ADDENDUM NO. 3

May 1, 2024

Blue River Valley Schools Renovations to:

Elementary School4713 Viking Trail
New Castle, IN 47362 **Jr. Sr. High School**4741 Viking Trail
New Castle, IN 47362

AD104

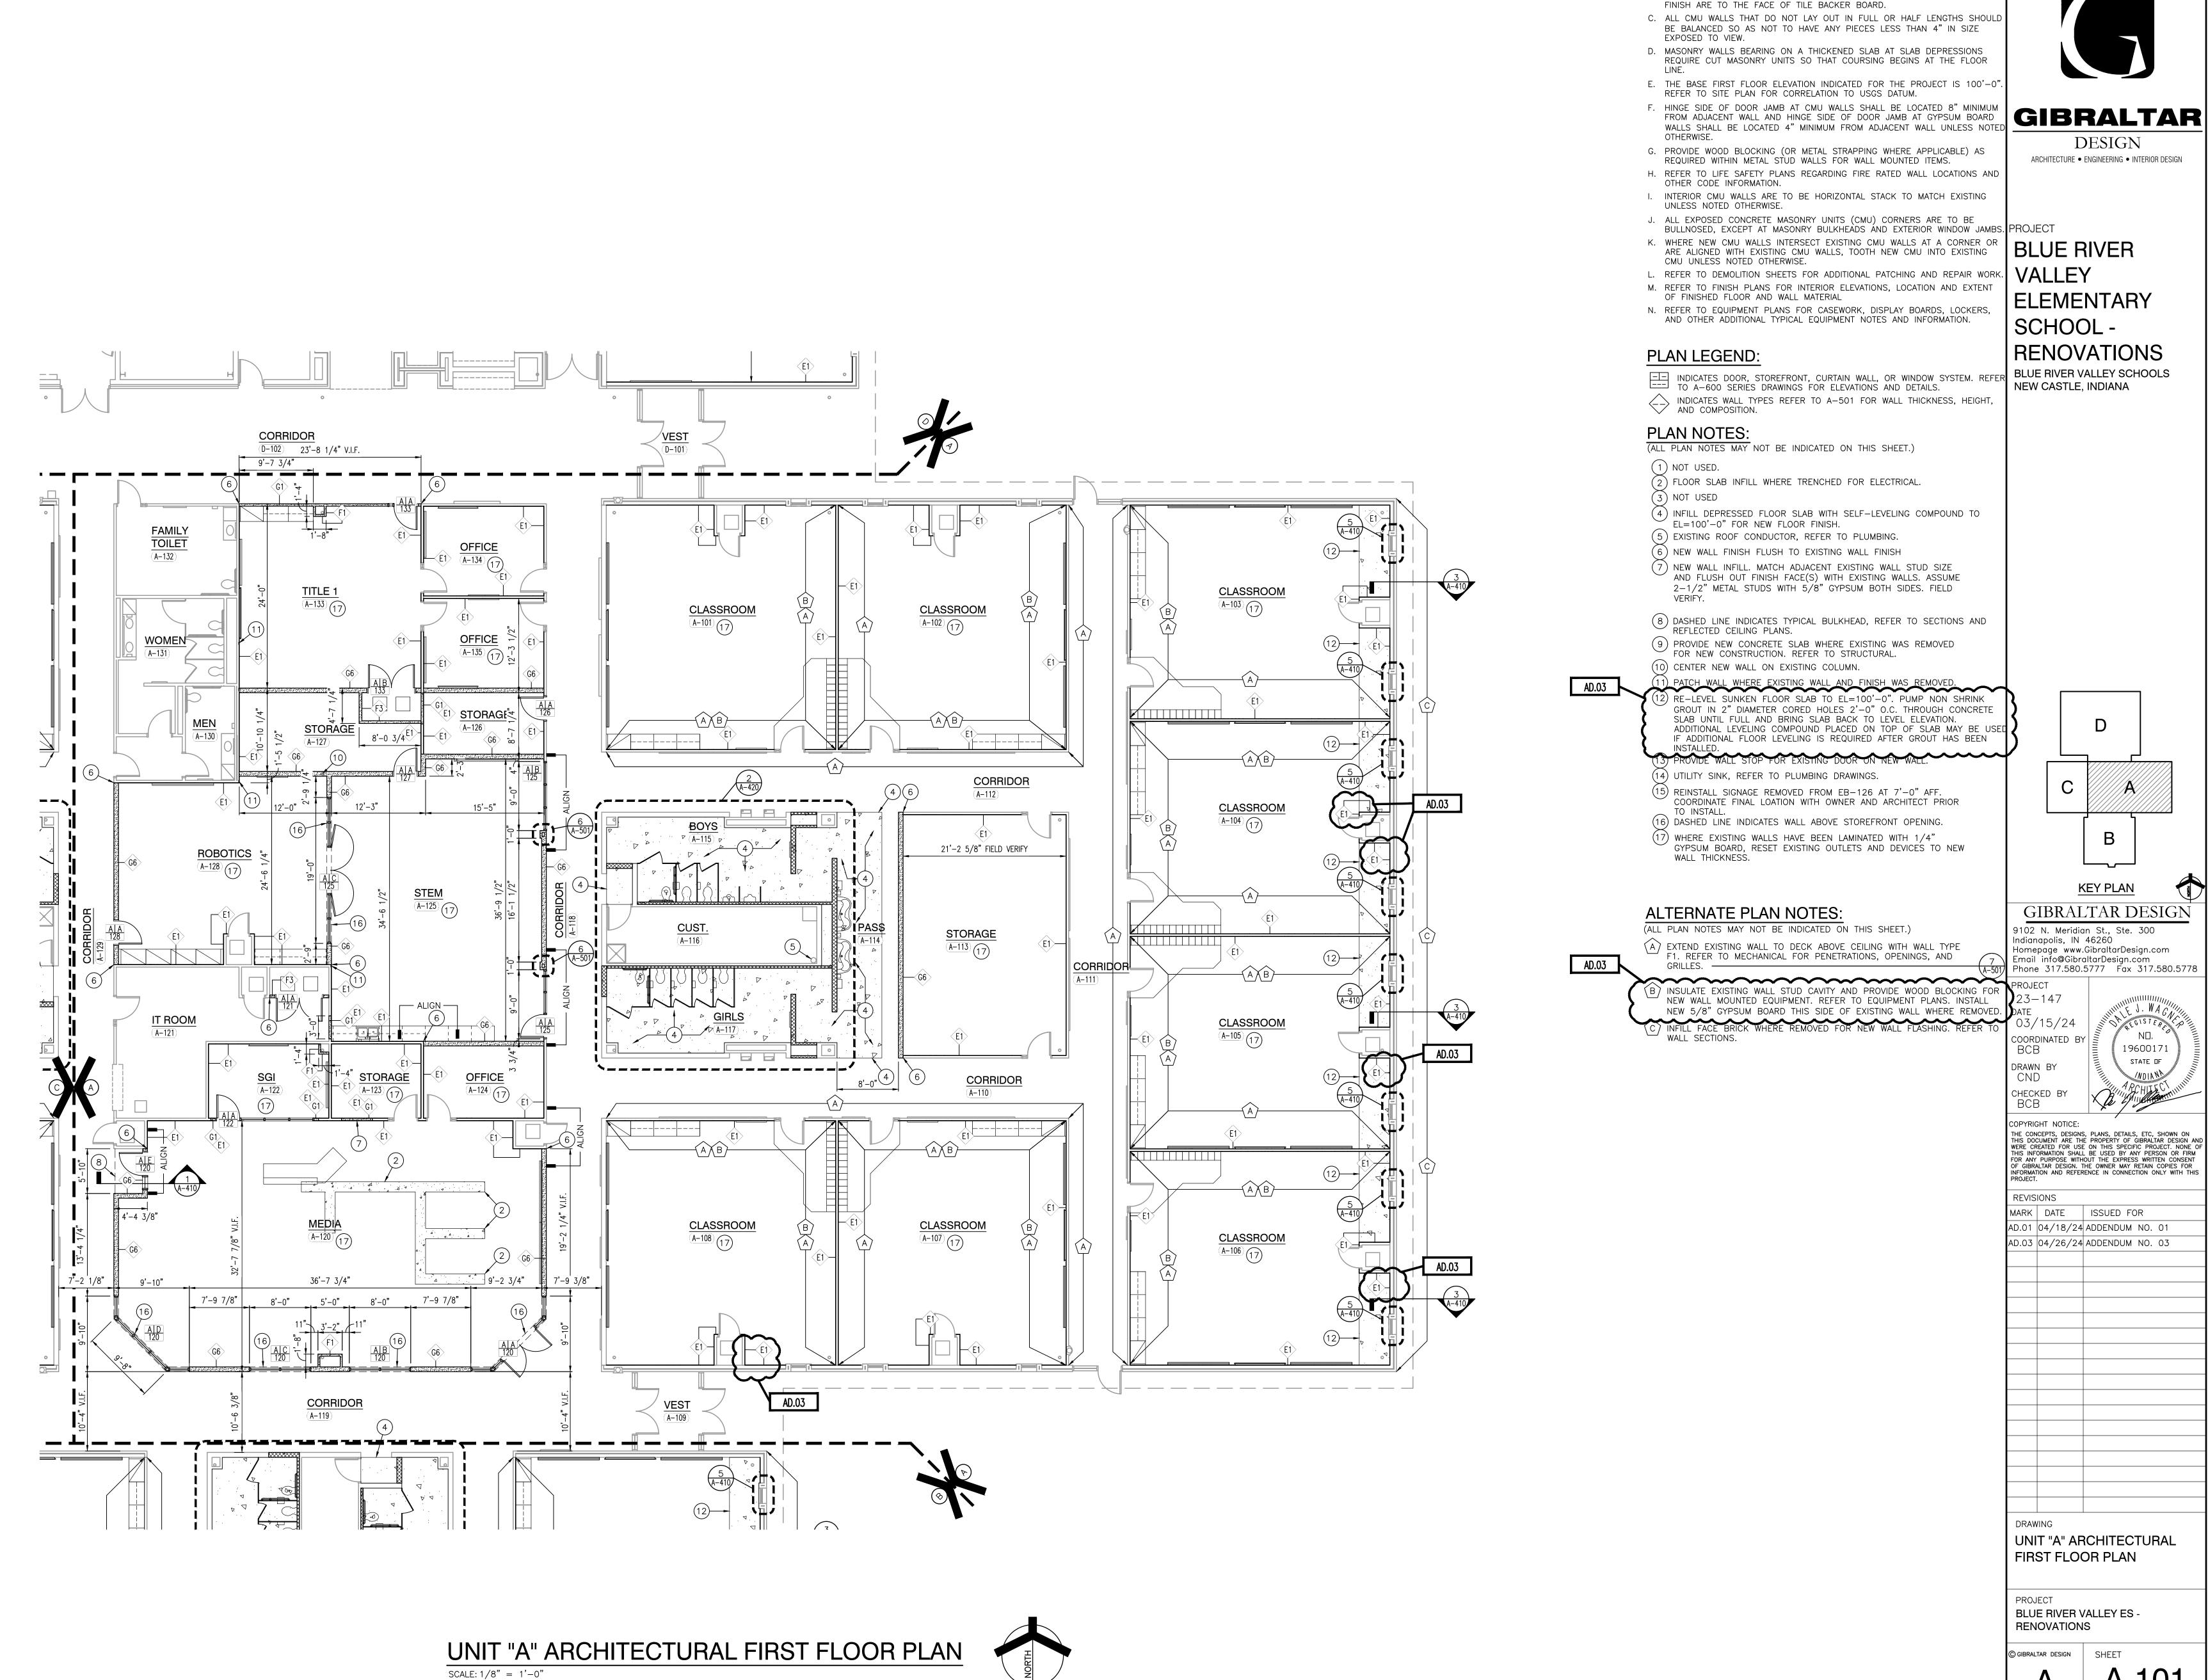
- 1. Sheet AD104
 - A. Refer to revised full size drawing included in this addendum for revisions.
- 2. Sheets A-101, A-102, A-103, A-104
 - A. Refer to four (4) revised full size drawings included in this addendum for revisions.
- 3. Sheet A-410
 - A. Refer to revised full size drawing included in this addendum for revisions.
- 4. Sheets A-801, A-802, A-803, A-804, A-820
 - A. Refer to five (5) revised full size drawings included in this addendum for revisions.

E-203

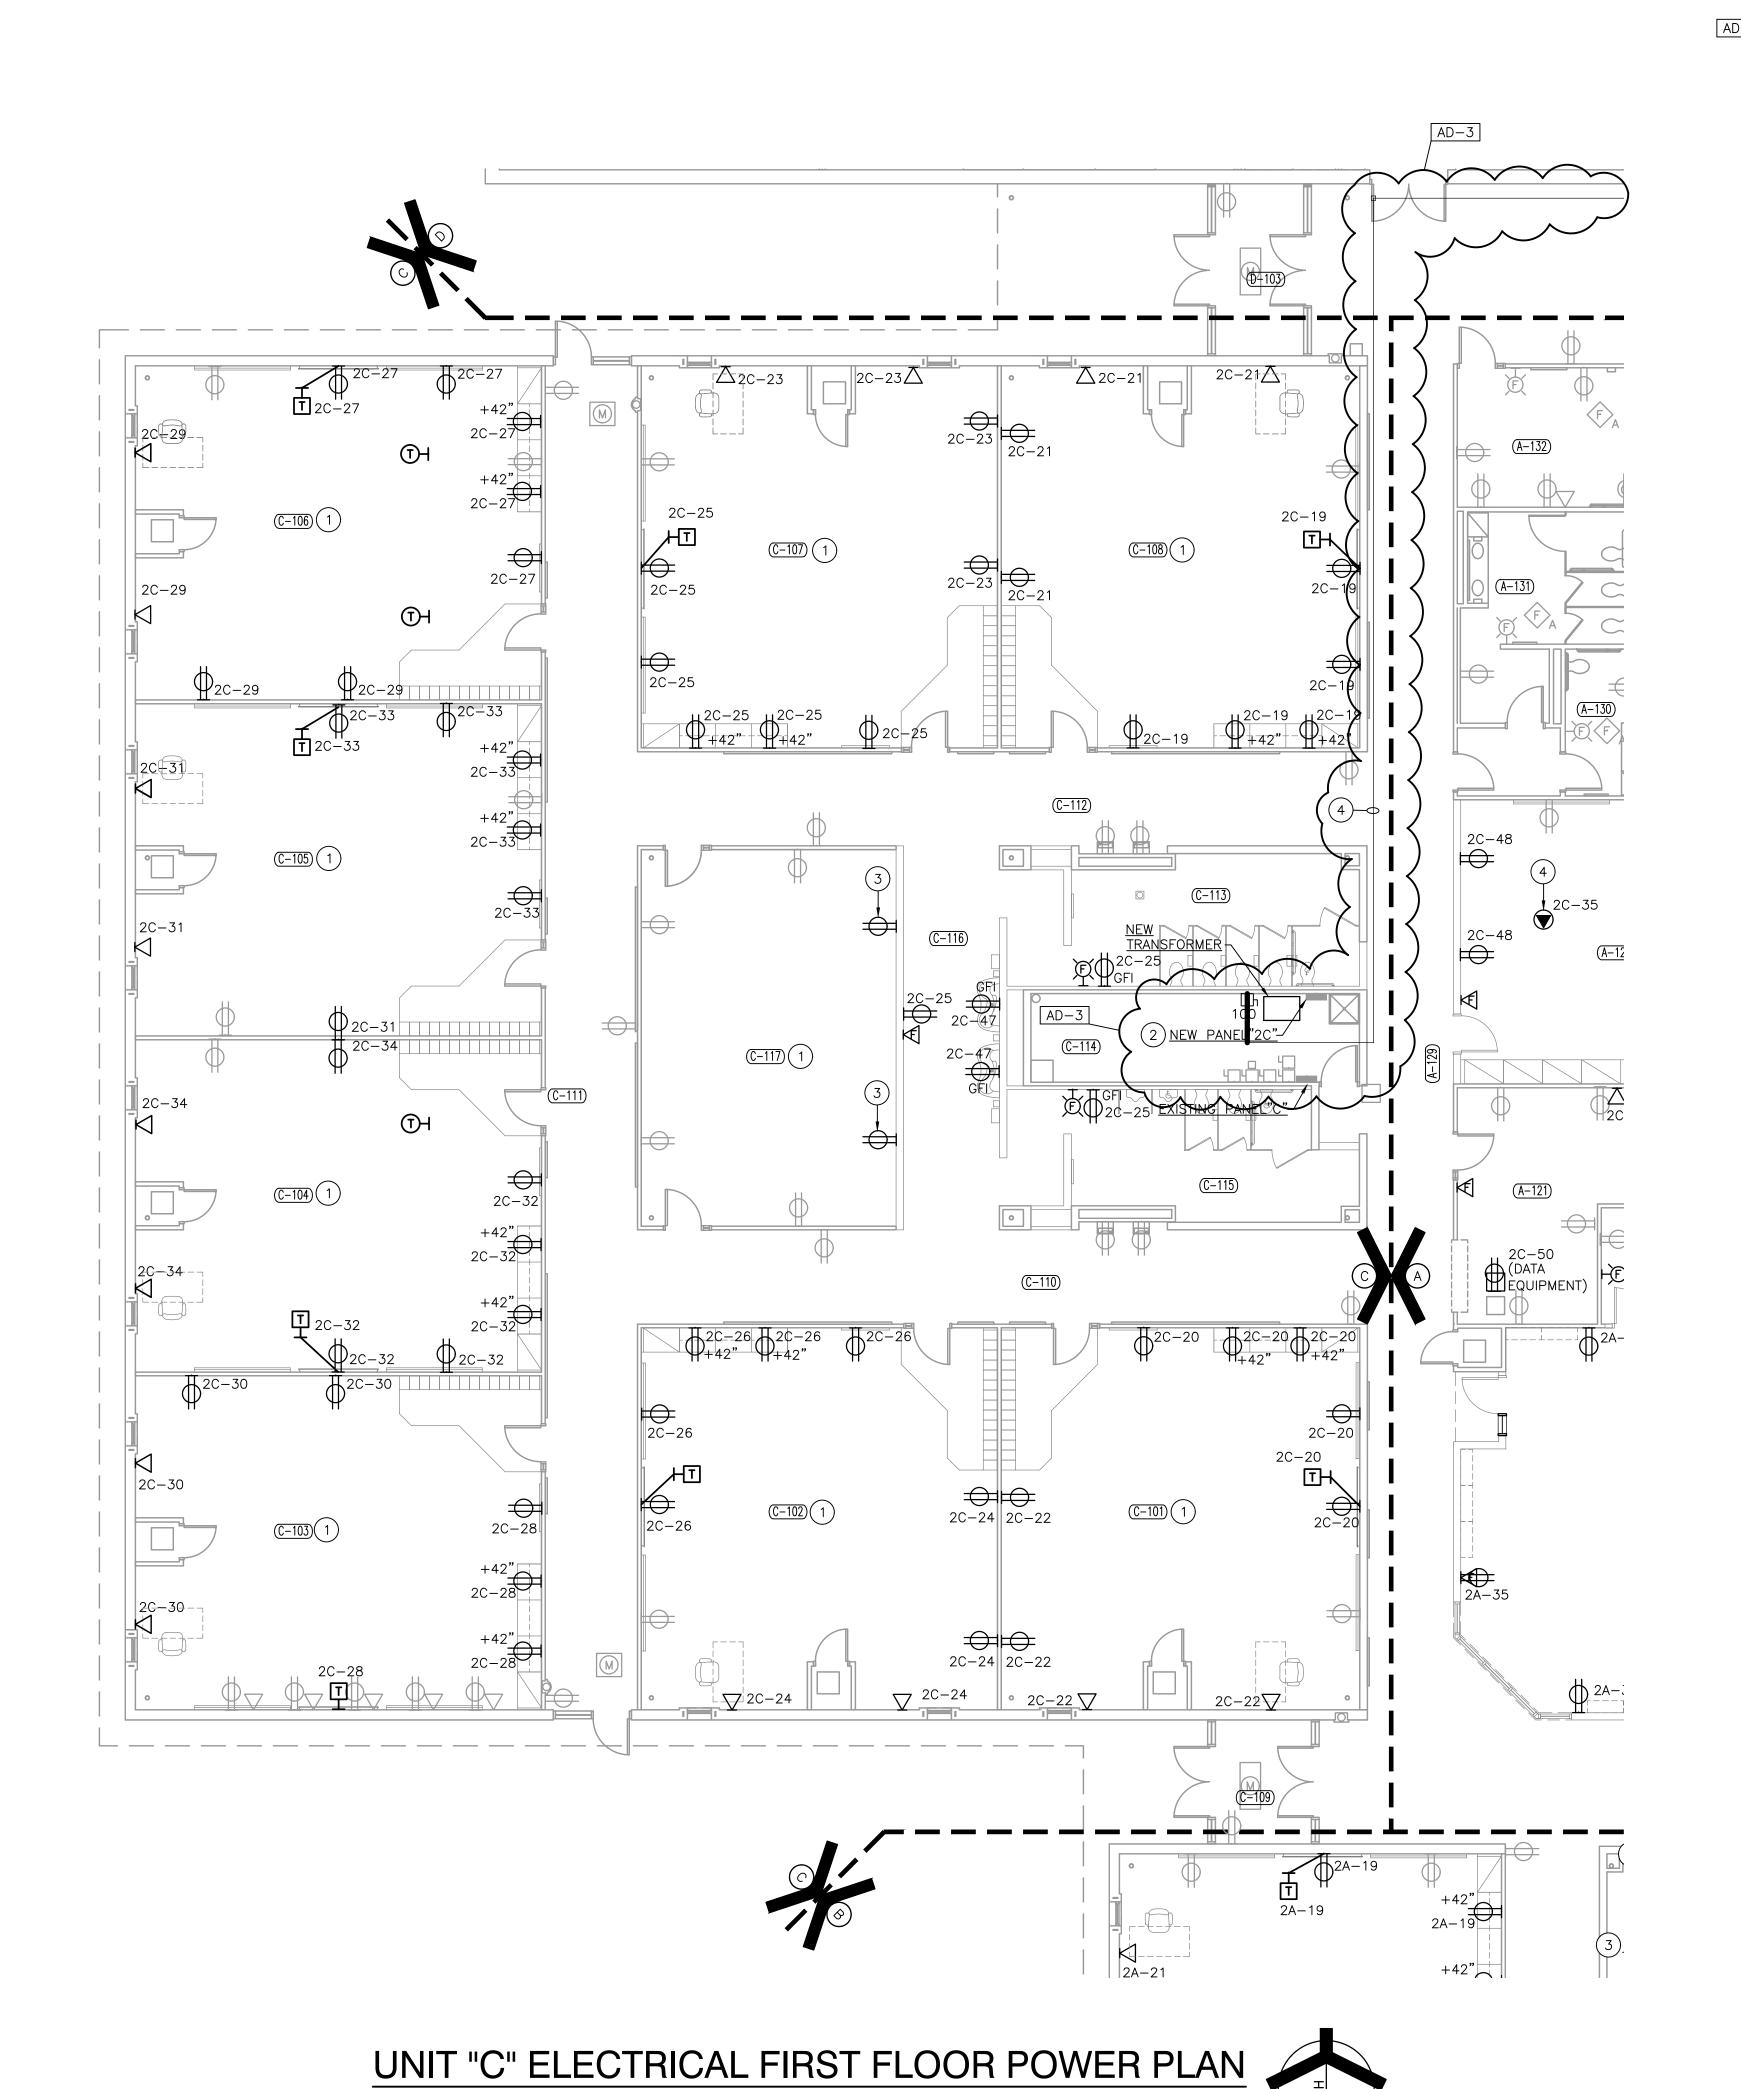
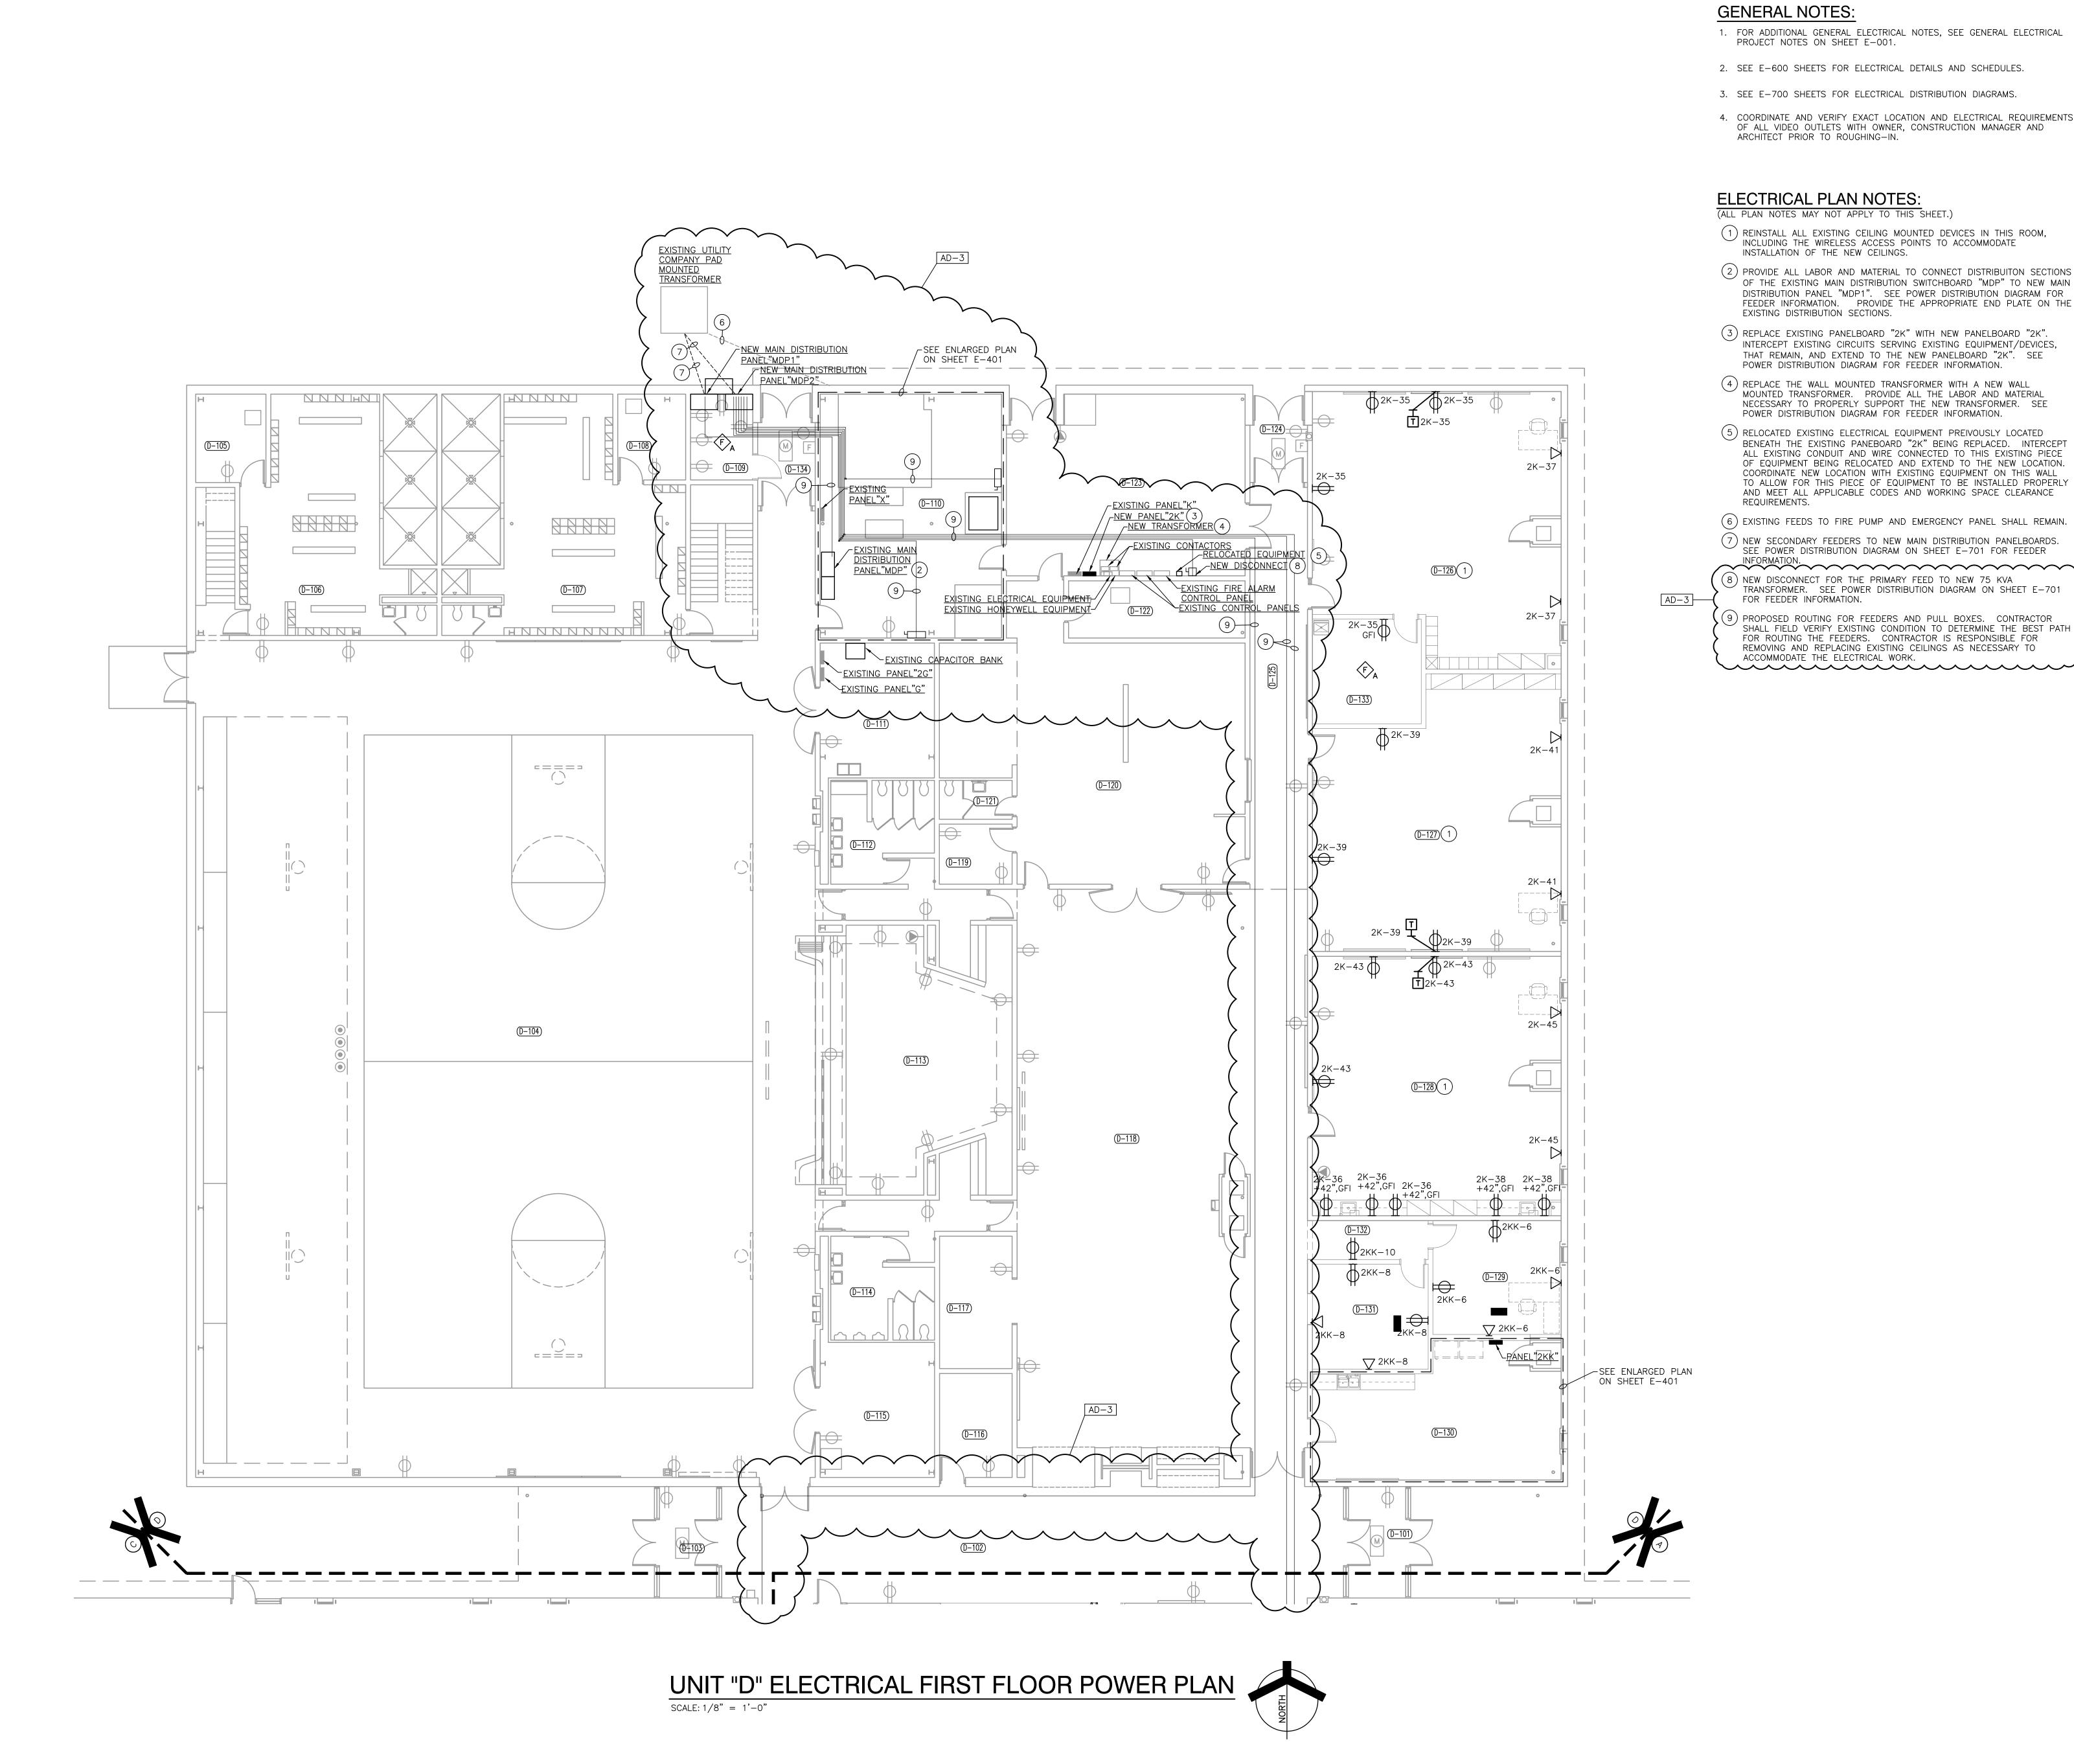
21. Sheet E-203

- A. Refer to revised full size drawings included in this Addendum for revisions, which includes as a minimum, the following revisions:
 - 1. Identifying the front of Panel "1L1".
